Delmore Fast-Track

04/05/2026 – Auckland Council Response

Delmore Fast Track Application

Re: Traffic Engineering Response Memorandum

Appendix 26b - Stage 2 Roding
and Access Drawings_ pg.5/53

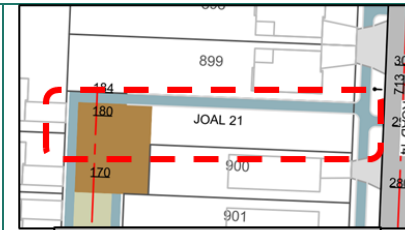
useful for a large community like Delmore, the provision of a designated loading bay will always support efficient usage, I am not in a position to support the non-compliance of the loading bay. Additionally, the parking of heavy vehicles will block the VC of the adjacent lot. Any furniture delivery or house relocation will take more than a minimal time. This has been discussed in the previous stage, and the applicant team agreed to provide the required loading bay prioritising at the JOALs with a high number of dwellings and length.	<u>JOAL 03</u> • Loading zone (full) provided in South - Lot 96 boundary adjusted. <u>JOAL 06</u> • Lot 373 boundary adjusted to enable a loading zone to be provided (full). <u>JOAL 11</u> • Lot 207 boundary adjusted to provide a full loading bay. <u>JOAL 40</u> • No boundary adjustments. • 2 loading bays added adjacent lot 142. <u>Stage 2</u> <u>JOAL 21</u> • Lot 900 boundary adjusted to enable truck turning. <u>JOAL 35</u>	- Stage 1 Roding and Access Drawings_ pg.4/51). This is considered acceptable. JOAL 03 No further comments. Noted proposed loading bay adjacent to lot 96 with 8mx5.2m (ref: Appendix 10a - Stage 1 Scheme Plans_ pg.8/45, Appendix 26a - Stage 1 Roding and Access Drawings_ pg.6/51). This is considered acceptable. JOAL 06 No further comments. Noted proposed loading bay adjacent to lot 96 with 4.5mx9.3m (ref: Appendix 10a - Stage 1 Scheme Plans_ pg.36/45, Appendix 26a - Stage 1 Roding and Access Drawings_ pg.5/51). This is considered acceptable. JOAL 11 No further comments. Noted proposed loading bay adjacent to lot 204 with 6.0mx6.8m (ref: Appendix 10a - Stage 1 Scheme Plans_ pg.20/45, Appendix 26a - Stage 1 Roding and Access Drawings_ pg.8/51). This is considered acceptable. <u>Further clarification:</u> <i><u>Minor inconsistency, as per applicant response, the loading bay is adjacent to lot 207 (report). However, on further</u></i>

Lot 1214 boundary adjusted to enable truck turning.	<u>assessment, it is adjacent to lot 204 (plan). Request to do necessary changes.</u> JOAL 40 No further comments. Noted proposed loading bay adjacent to lot 142 with ~8.0mx5.6m (ref: Appendix 10a - Stage 1 Scheme Plans_ pg.14/45, Appendix 26a - Stage 1 Roding and Access Drawings_ pg.6/51). This is considered acceptable. Stage 2 JOAL 21 No further comments. Noted proposed truck turning area adjacent to lot 900 with ~15mx12m dimensions (ref: Appendix 10b - Stage 2 Scheme plans_ pg.45/49, Appendix 26b - Stage 2 Roding and Access Drawings_ pg.5/53). This is considered acceptable. <u>Further clarification:</u> <u>Request to update the inconsistency in the scheme plan of JOAL 21 and lot 899.</u>
--	---	--

No further comments. Noted proposed truck turning area adjacent to lot 1214 with ~10mx10mm dimensions (ref: Appendix 10b - Stage 2 Scheme plans_ pg.27/49, Appendix 26b - Stage 2 Roding and Access Drawings_ pg.8/53). This is considered acceptable.
